United States Department of the Interior

BUREAU OF RECLAMATION
Mid-Pacific Region
Klamath Basin Area Office
6600 Washburn Way
Klamath Falls, OR 97603-9365

Subject: Addendum to the Proposed Action included in the Bureau of Reclamation's December 21, 2018, *Final Biological Assessment on the Effects of the Proposed Action to Operate the Klamath Project from April 1, 2019 through March 31, 2029 on Federally-Listed Threatened and Endangered Species*

Change to Tule Lake Sump 1A Minimum Elevation

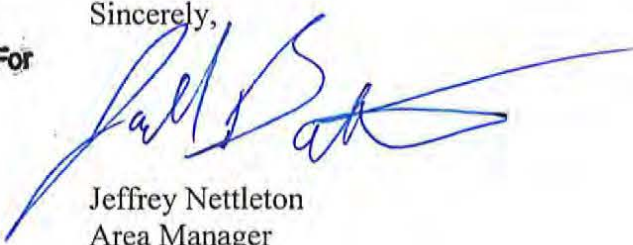
Reclamation is proposing to change the April 1 through September 30 Tule Lake Sump 1A minimum elevation from 4,034.6 ft to 4,034.0 ft. The purpose of this modification is increased flexibility in Tulelake Irrigation District and Pumping Plant D operations, which will thereby provide more flexibility for Lower Klamath National Wildlife Refuge deliveries. See Part 4.3.2.2.7 in the attached revised PA for specific revisions.

Past seasonal water level operations of 4034.0 ft (Oct 1 – March 31) and 4034.6 feet (ft; April 1- Sept 30) have resulted in water levels in Tule Lake sumps (1A and 1B) generally less than 5 ft water depth. These operations and resultant water depths appear to provide adequate habitat for larval and juvenile Lost River and shortnose sucker life stages (USFWS 2008; 2013). A year-round minimum surface elevation of 4034.0 ft is likely to preserve areas of Sump 1A with a water depth of at least 4 ft, providing adult suckers with protection from fish-eating birds.

Relative to water quality, the slightly lower surface elevation of 4034.0 ft may permit emergent wetland vegetation to establish seasonally in Sump 1A, which could enhance water quality conditions during the growing season via nutrient uptake (Geiger 2001 *in* USFWS 2008).

The proposed change in operation at Tule Lake Sump 1A to a year-round minimum surface elevation of 4034.0 ft is not anticipated to have negative impacts to suckers or sucker habitat in the sump.
